November 18, 2019

TO	:	All Bidders
FROM	:	Mark Graham
PROJECT	:	Barton Elementary School Modernization
		Project 1720100.41
SUBJECT	:	Addendum 1
DSA	:	04-118157 / File 36-55

SCHEDULES

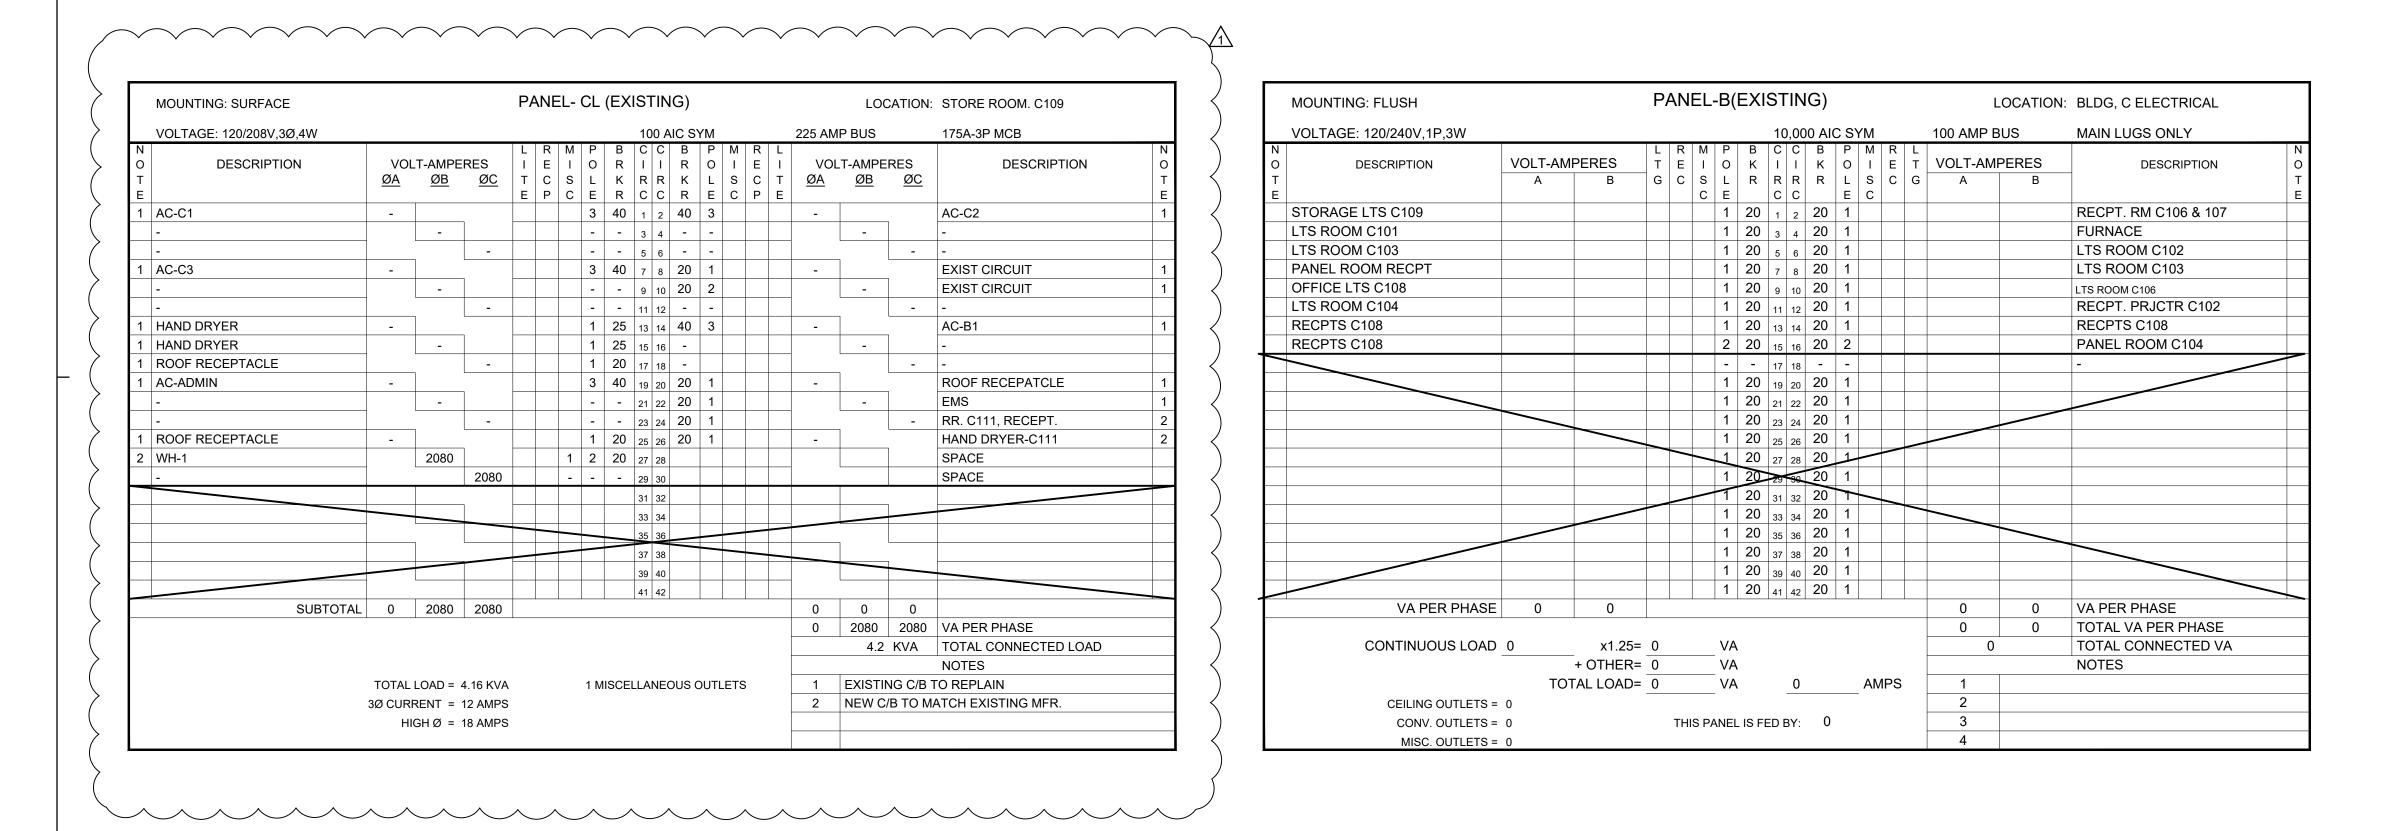
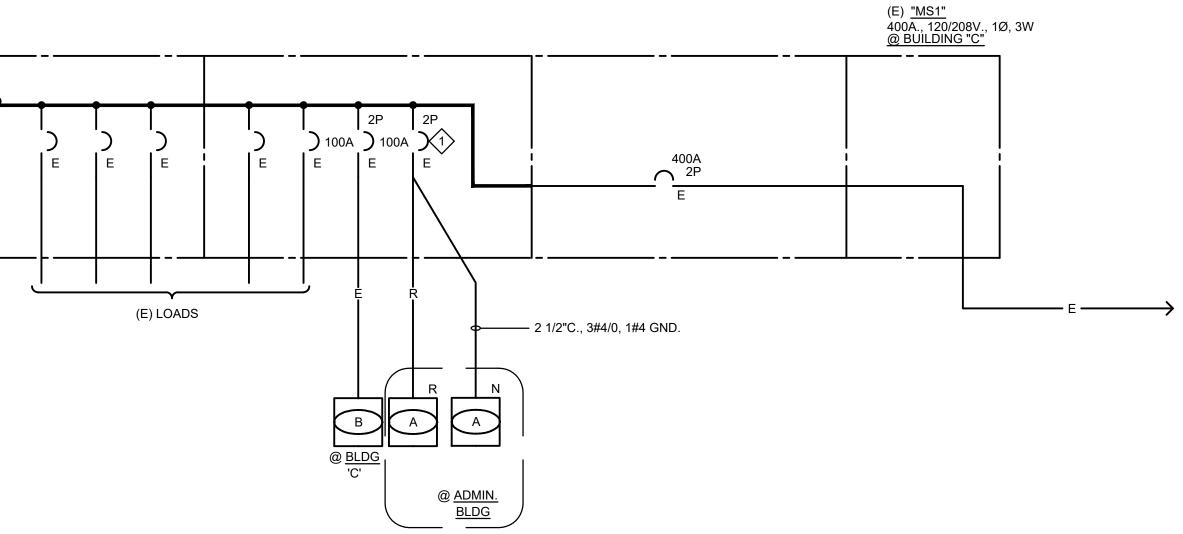
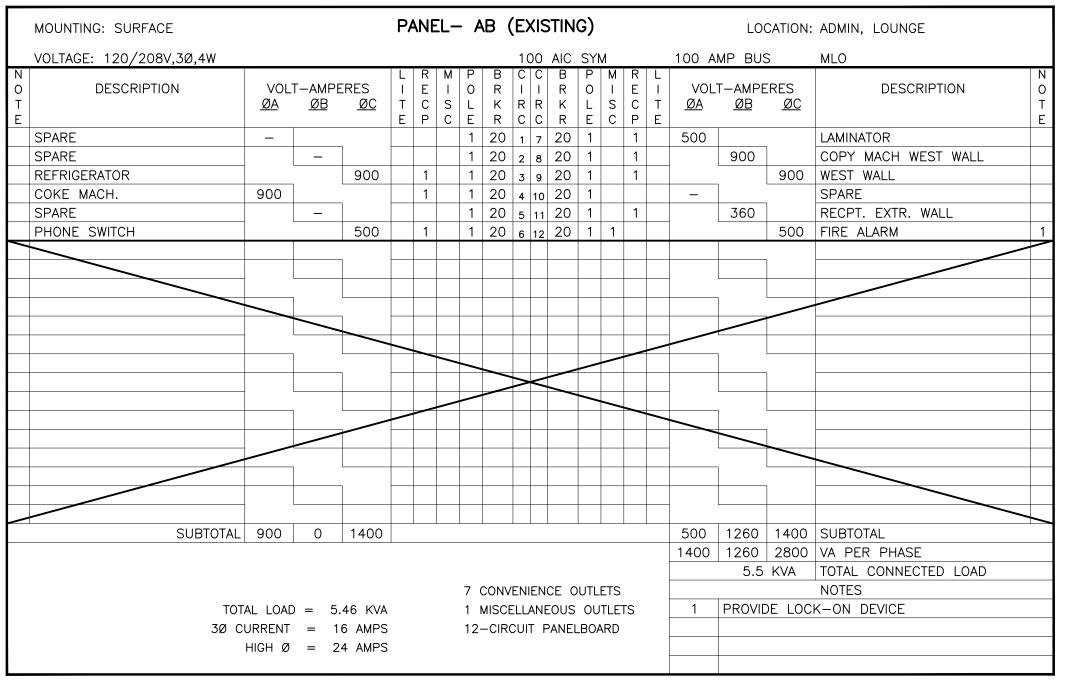
- 1.49 GENERAL ITEMS FOR ALL TRADES
 - A. The word "Minte" shall mean "Minute" typical throughout.
- 1.50 DRAWING E0.2 (Refer to clouded areas on attached drawing)
 - A. Panel schedule "CL" added.
 - B. Lighting fixture "F" mounting height and catalog number revised.
 - C. Lighting fixture "D" catalog number revised.
- 1.51 DRAWING E1.1 (Refer to clouded areas on attached drawing)
 - A. Revise Panel "AB" from "E" to "RR".
- 1.52 DRAWING E2.1 (Refer to clouded areas on attached drawing)
 - A. Light fixture in Building A, Room "A8" turned 90°.

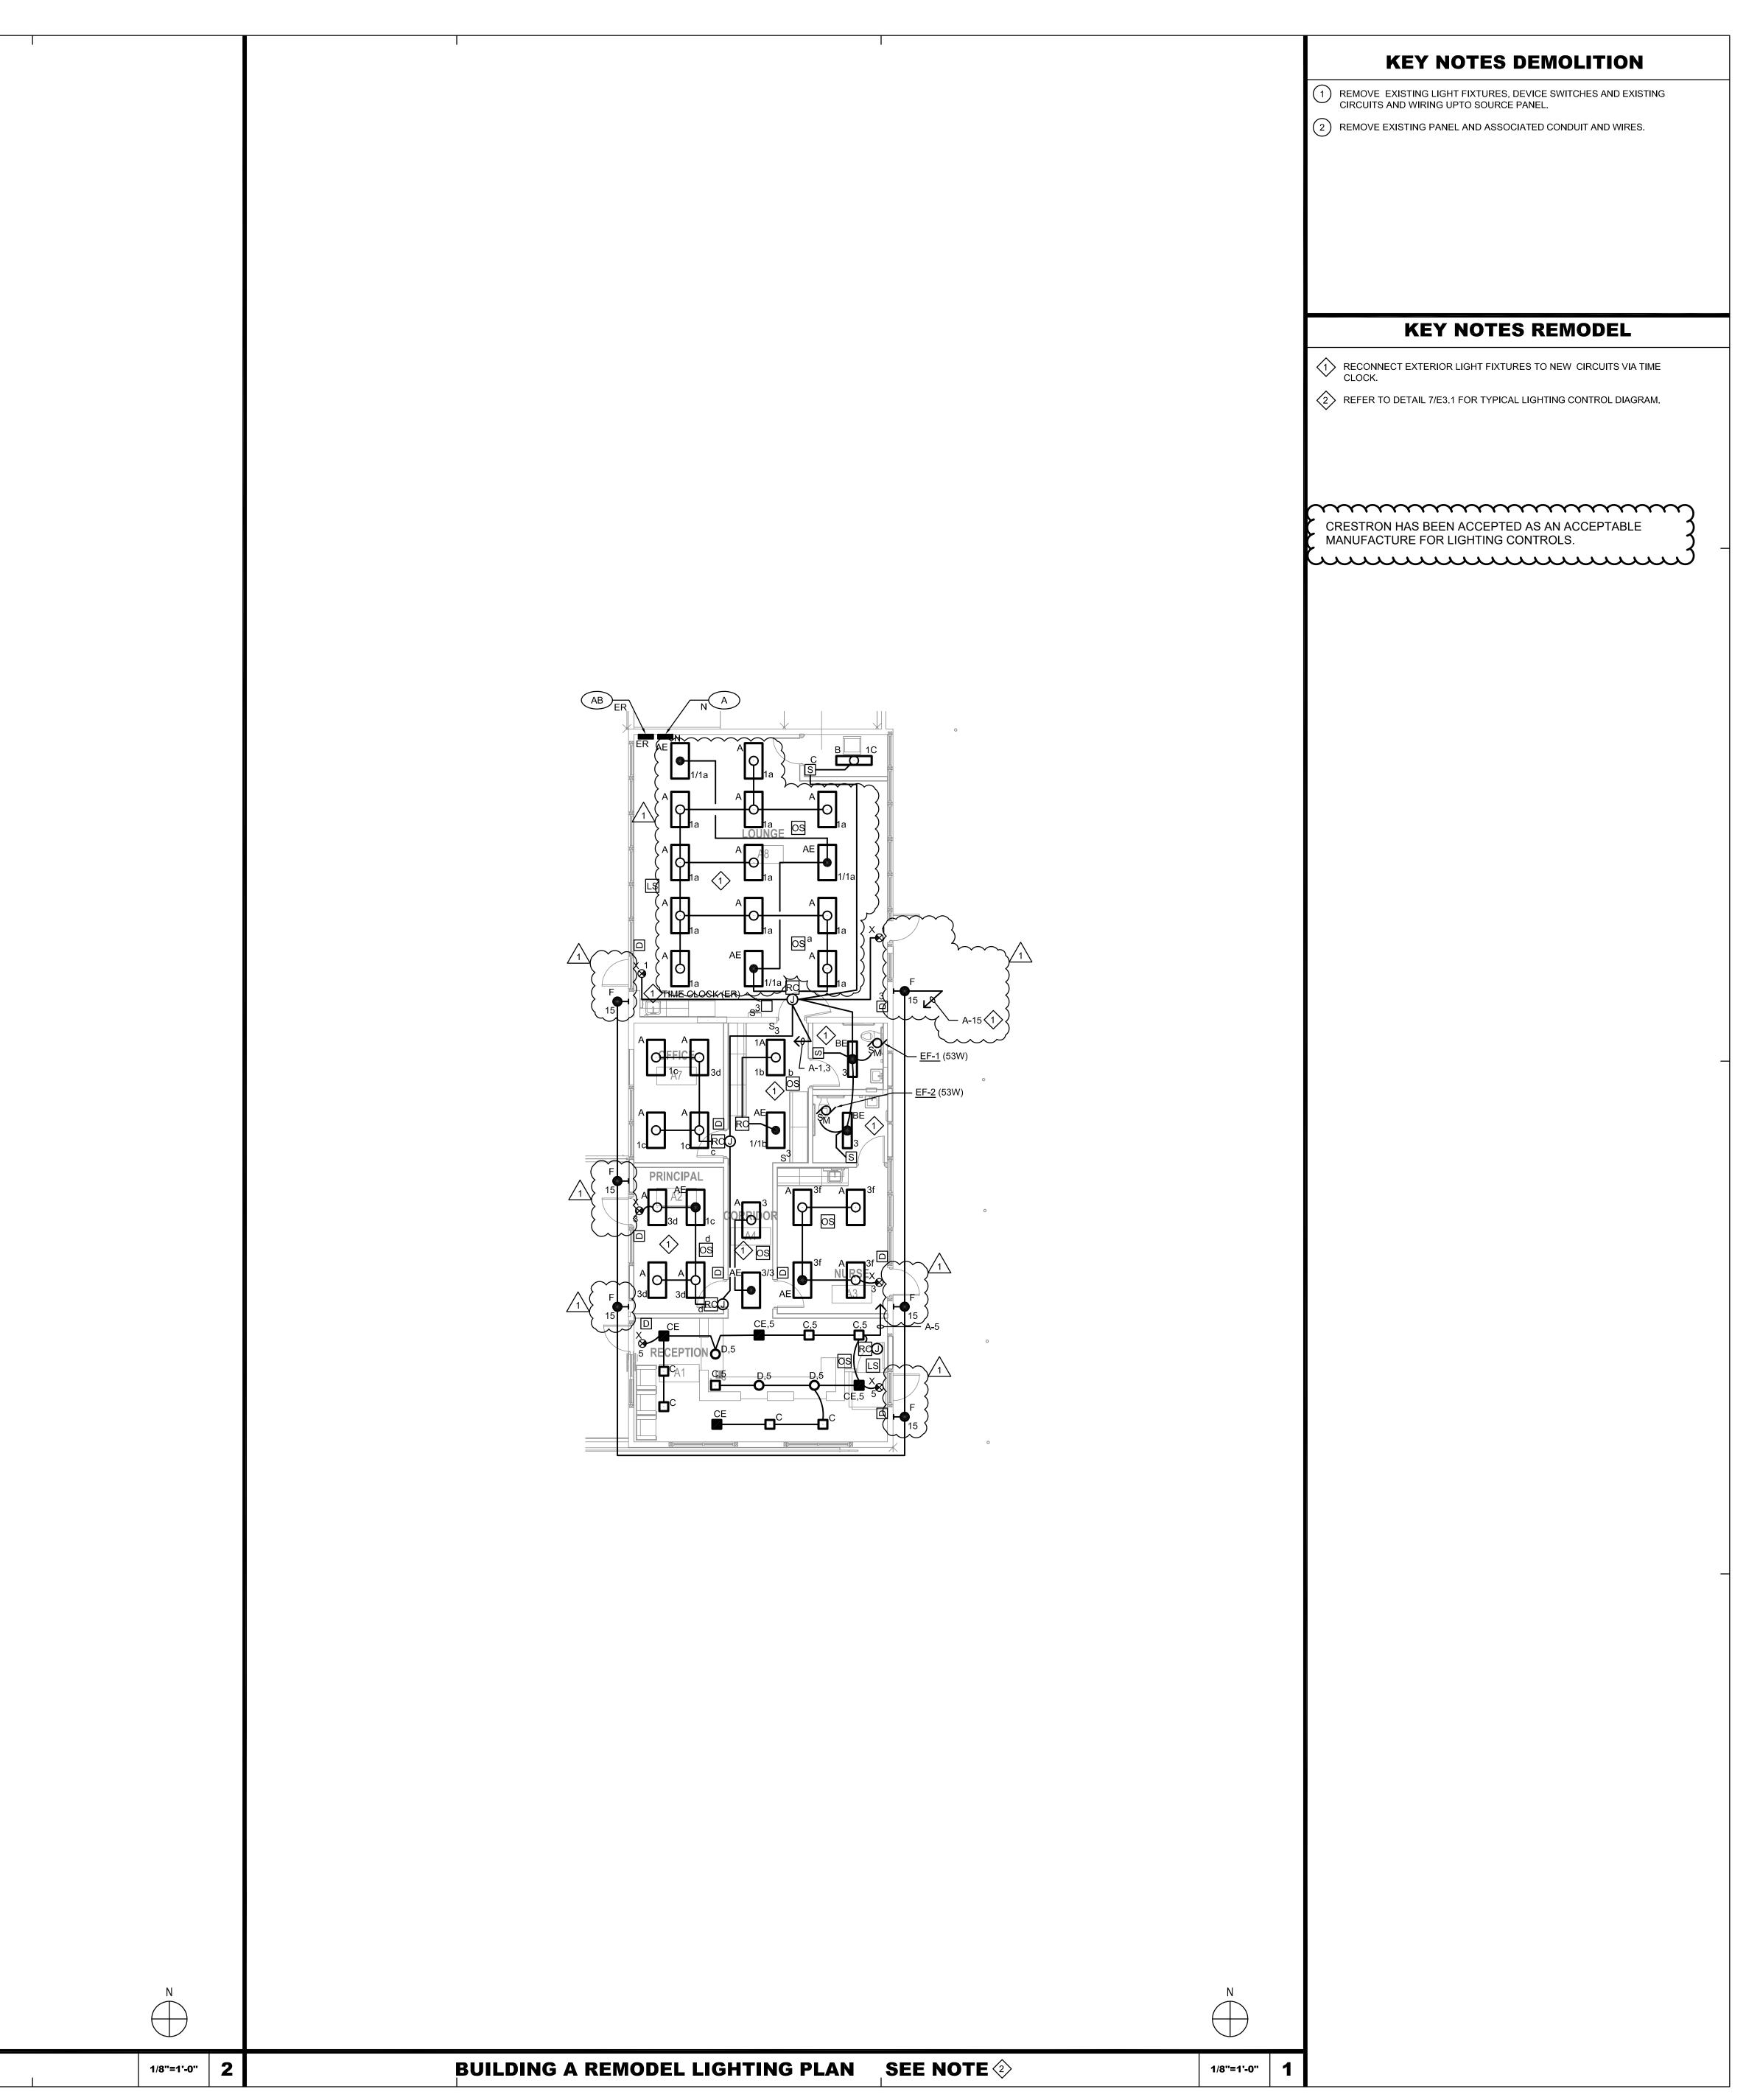
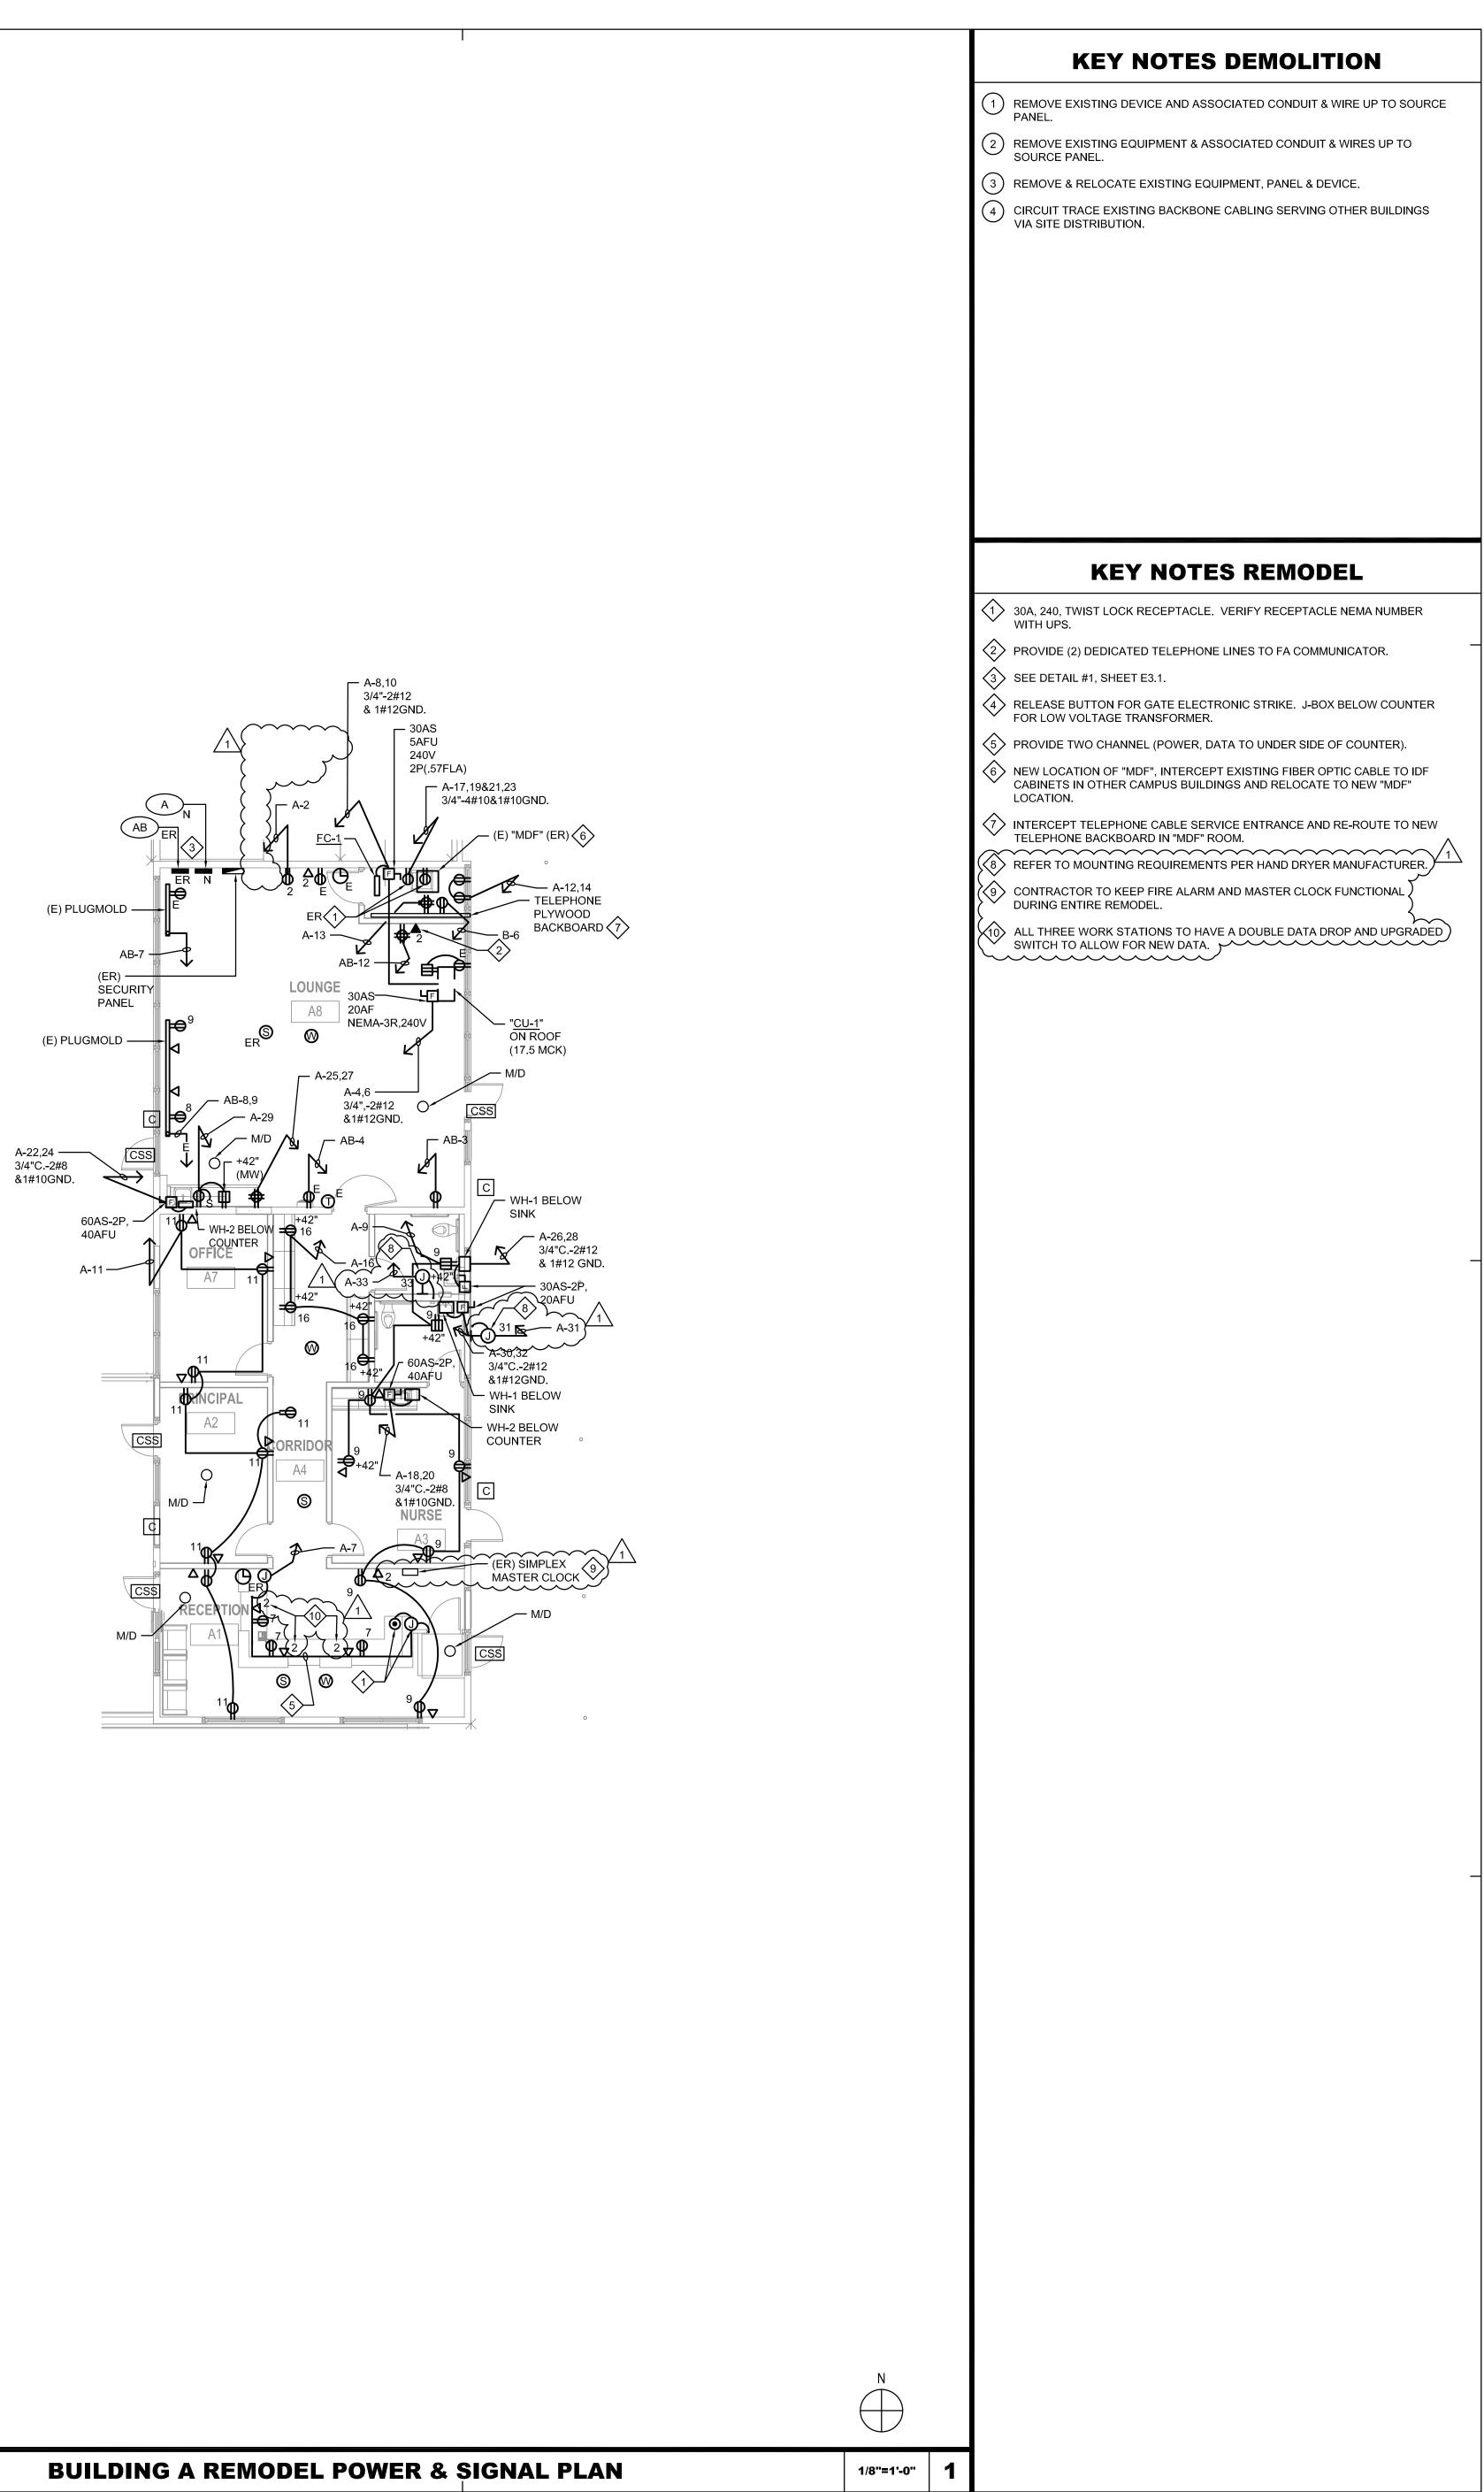
- B. Move exterior light fixture "F".
- 1.53 DRAWING E2.2 (Refer to clouded areas on attached drawing)
 - A. Detail 1
 - 1. Add power for hand dryer in restrooms.
 - 2. Move master clock to Reception "A1".
 - 3. Add Note 10 to Reception "A1" desk.
 - B. Detail 2
 - 1. Revise Panel "AB" in Room "A8" to "RR" from "E".
